Access Compliance Report

Public Rights-of-Way

(Curb Ramps)

Intersection ID: 10018079	Main Street: CORRIENTE_CT	Cross Street: N/A	Location: SW
ADA ID: 985A88EF06DE	Ramp Type: Perp	Initial Pass/Fail: Fail	Overall Compliance: No
Severity Score: 8.75			
Codes/Mitigation Info/Possible Solution		Field Measurements/Component Compliance

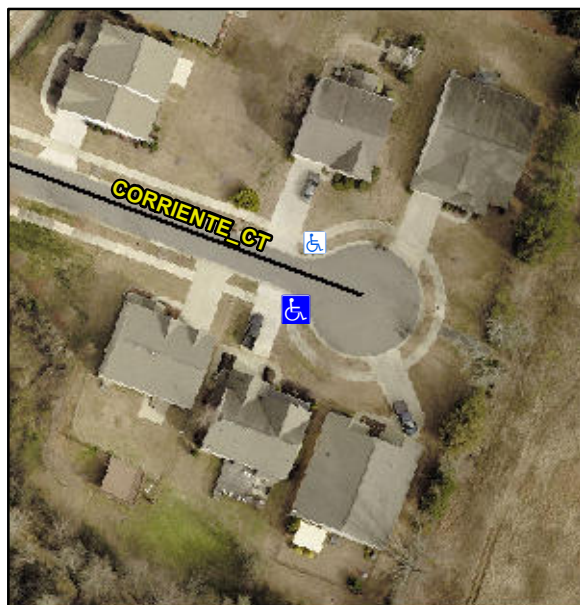
Not Found, R304.5.1

Compliance	Description	Data	Compliance	Description	Data
N/A	Ramp Length (in)	71.0	Yes	Ramp Slope (%)	5.1
No	Ramp Width (in)	47.5	Yes	Ramp XSlope (%)	0.7
N/A	Flare Type LT	N/A	N/A	Flare Type RT	N/A
N/A	Flare Slope LT (%)	N/A	N/A	Flare Slope RT (%)	N/A
N/A	Flare Traversable LT?	N/A	N/A	Flare Traversable RT?	N/A
N/A	Landing Length (in)	N/A	N/A	DWS Provided?	N/A
N/A	Landing Width (in)	N/A	N/A	DWS Contrast?	N/A
N/A	Landing Slope (%)	N/A	N/A	DWS Length (in)	N/A
N/A	Landing X Slope (%)	N/A	N/A	DWS Full Width?	N/A
N/A	Landing Curb? (Y/N)	N/A	N/A	DWS Offset (in)	N/A
N/A	Shared Landing?	N/A			
N/A	Gutter Ponding?	N/A	N/A	Gutter Slope (%)	N/A
N/A	Gutter Lip Ht (in)	N/A	N/A	Gutter X Slope (%)	N/A
N/A	Painted X Walk1?	No	N/A	Painted X Walk2?	N/A
	X Walk 1 Direction	To N		X Walk 2 Direction	N/A
N/A	X Walk 1 Width (in)	N/A	N/A	X Walk 2 Width (in)	N/A
	X Walk 1 Slope (%)	3.9		X Walk 2 Slope (%)	N/A
	X Walk 1 X Slope (%)	3.6		X Walk 2 X Slope (%)	N/A

Remove & Replace Entire Ramp.
